SERVICE PROCEDURE

G-04510-R1
February 2006

SUBJECT: **SAFETY RECALL (U.S., EXPORT)**
BATTERY CABLES on certain HPV models built
11/20/2000 thru 5/20/2004 with Cummins,
Caterpillar or International DT/HT530 engines.

REVISION DESCRIPTION

**Figure 3 --
Chafing may occur between Engine Block Ground and Newly Located Positive cables.**

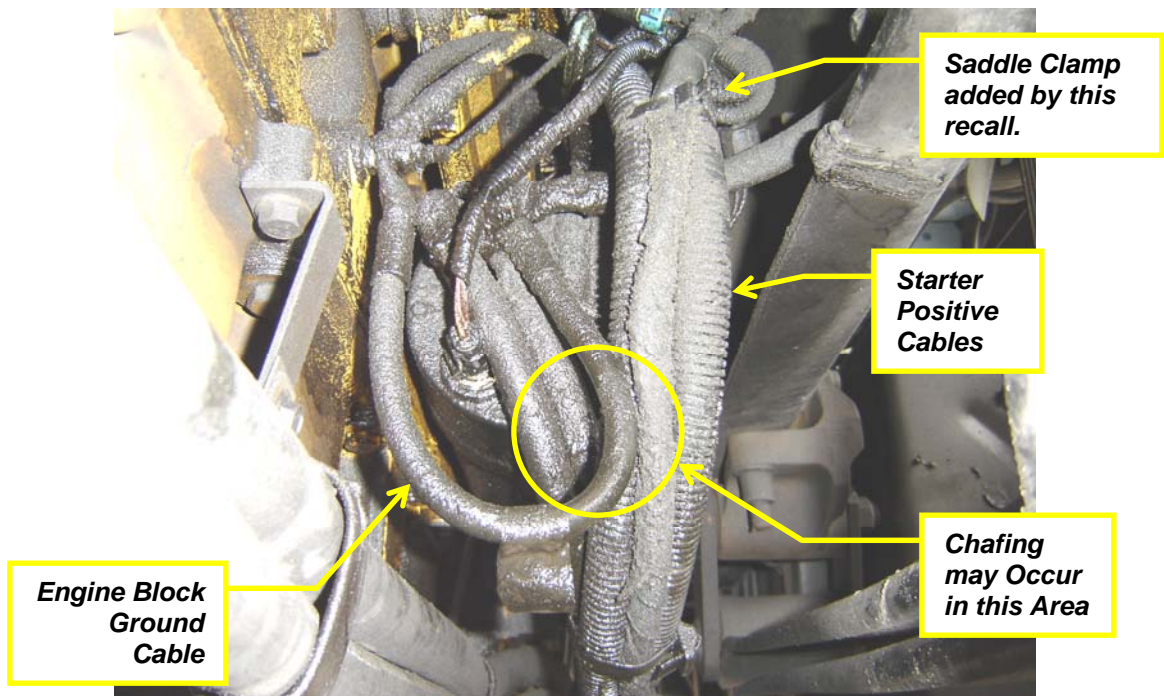
TO PREVENT CHAFING OF THE POSITIVE CABLES AGAINST THE ENGINE BLOCK GROUND CABLE (SEE FIGURE 3), PLEASE ENSURE ENGINE BLOCK GROUND CABLE IS CLOCKED IN THE DOWNWARD (6 O'CLOCK) POSITION, SEE FIGURE 4.

- *If rubbing or chafing of the ENGINE GROUND cable against the Battery Cables is present, rotate and tighten the new ground cable on the starter terminal so it is straight down (6 o'clock position) and not contacting the starter positive cables, see figure 4.*
